737

Service Bulletin

Number: 737-24-1165
Original Issue: April 28, 2005
Revision 2: April 29, 2015
ATA System: 2434

SUBJECT: ELECTRICAL POWER - Standby Power System - Removal and Replacement of the Static Inverter Module

**FIGURE 1: REMOVAL OF THE STATIC INVERTER
(SHEET 1 OF 1)**

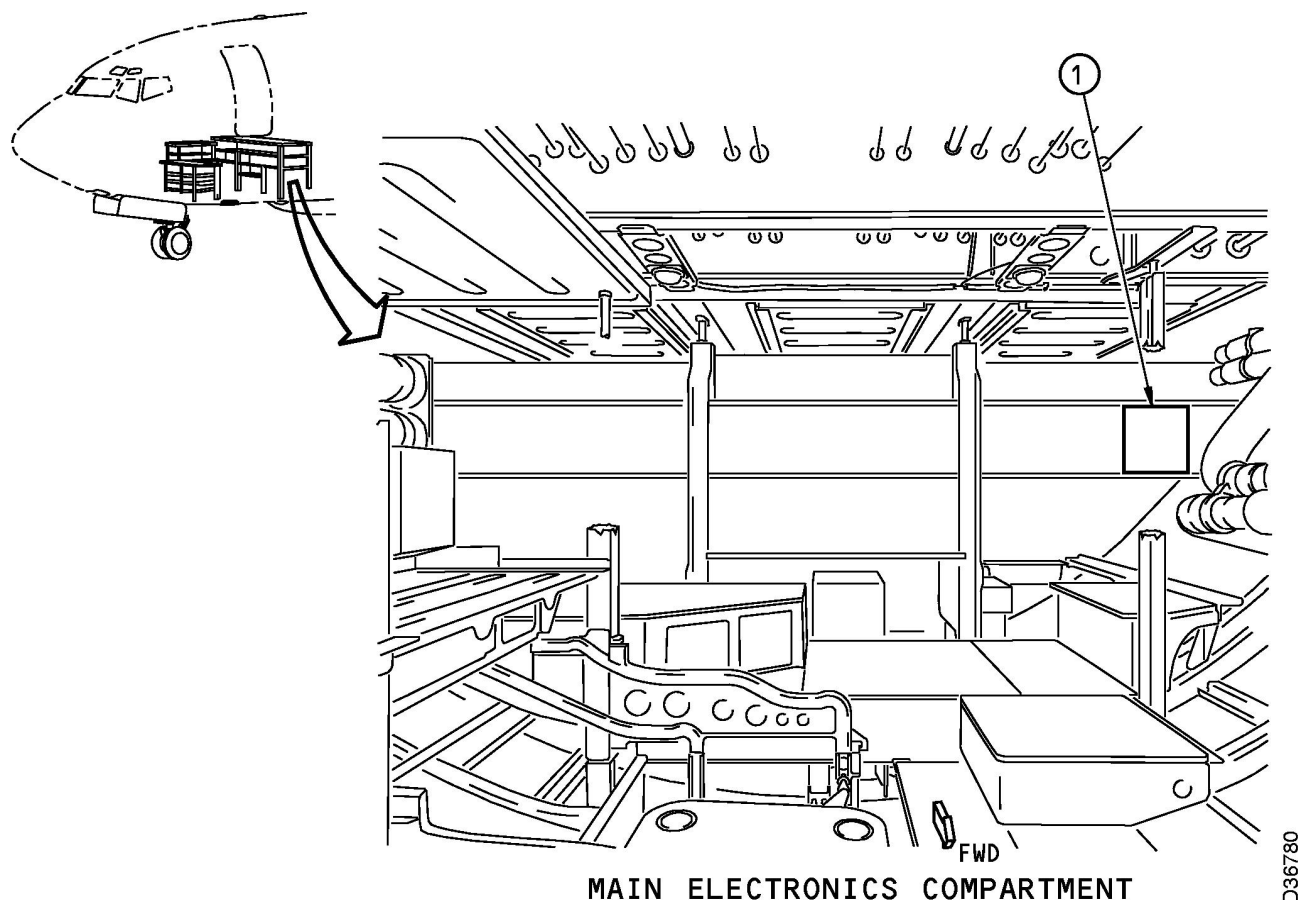
3. In the main electronic equipment compartment, remove the static inverter from the E2-2 electronics shelf in accordance with FIGURE 1.

STEP	TASK	PART NAME	IDENTIFICATION	QTY	MORE DATA
1	Remove	Static Inverter	S282T004-10 (Supplier Part Number: 1-002-0102-1000) or S282T004-20 (Supplier Part Number: 1-002-0102-2062)	1	(a)
(a) From the E2-2 electronics shelf. Refer to 737-600/700/800/900 AMM 20-10-07 and 737-600/700/800/900 AMM 24-34-21 as an accepted procedure.

**FIGURE 2: INSTALLATION OF THE STATIC INVERTER
(SHEET 1 OF 1)**

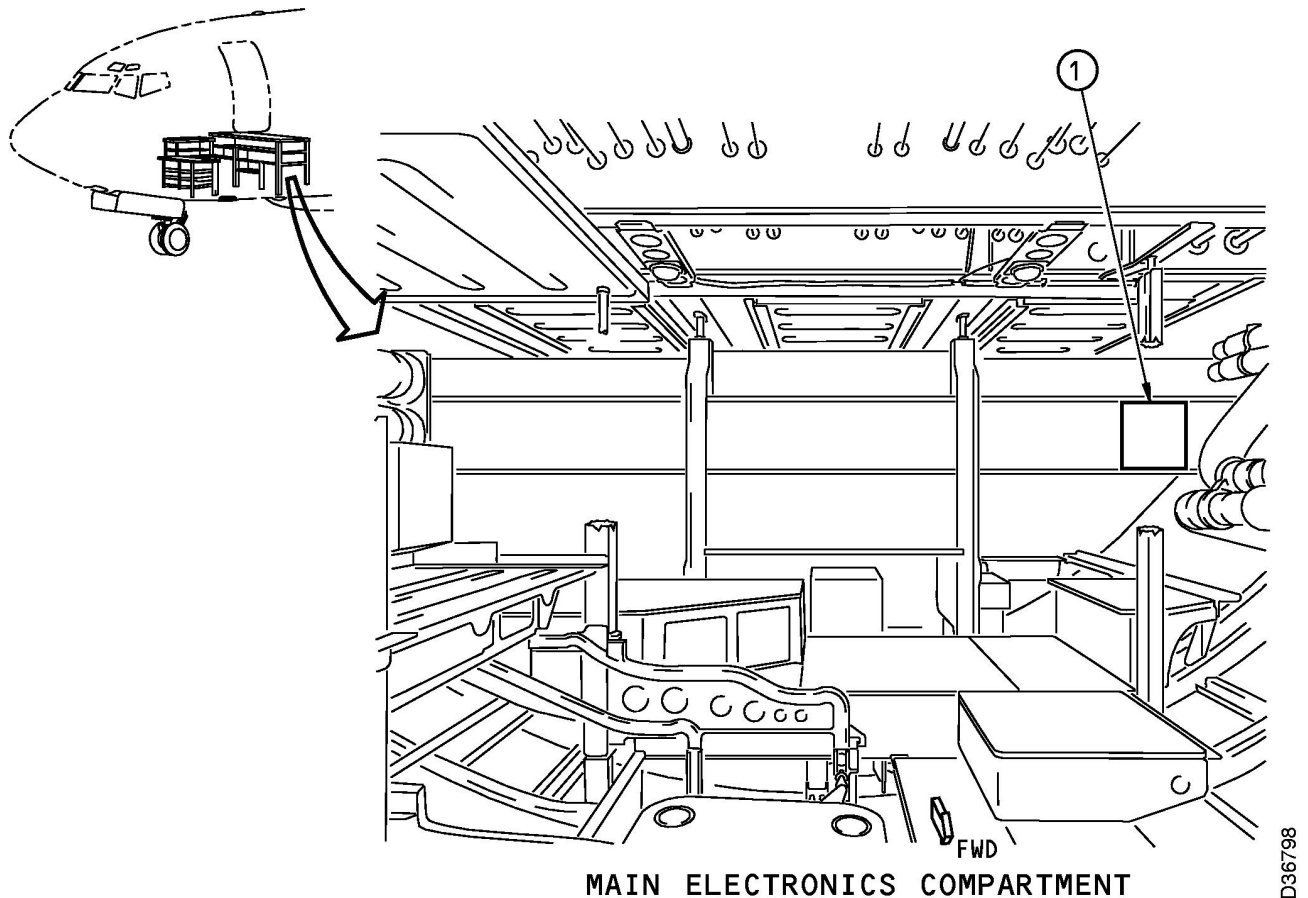
4. Install a new or changed static inverter on the E2-2 electronics shelf in accordance with FIGURE 2.
5. Apply electrical power to the airplane. Refer to 737-600/700/800/900 AMM 24-22-00, 737-600/700/800/900 AMM 24-34-21 as an accepted procedure.
6. Do the Static Inverter Installation Test to make sure that the static inverter operates correctly. Refer to 737-600/700/800/900 AMM 24-34-21 as an accepted procedure.
7. Remove electrical power from the airplane. Refer to 737-600/700/800/900 AMM 24-22-00, 737-600/700/800/900 AMM 24-34-21 as an accepted procedure.

STEP	TASK	PART NAME	IDENTIFICATION	QTY	MORE DATA
1	Install (New or Changed)	Static Inverter	S282T004-30 (Supplier Part Number: 1-002- 0102-2090) or S281W204-1 (Supplier Part Number: 1-002- 0102-2170)	1	(a)
(a) On the E2-2 electronics shelf. Refer to 737-600/700/800/900 AMM 20-10-07, 737-600/700/800/900 AMM 20-50-11 and 737-600/700/800/900 AMM 24-34-21 as an accepted procedure.
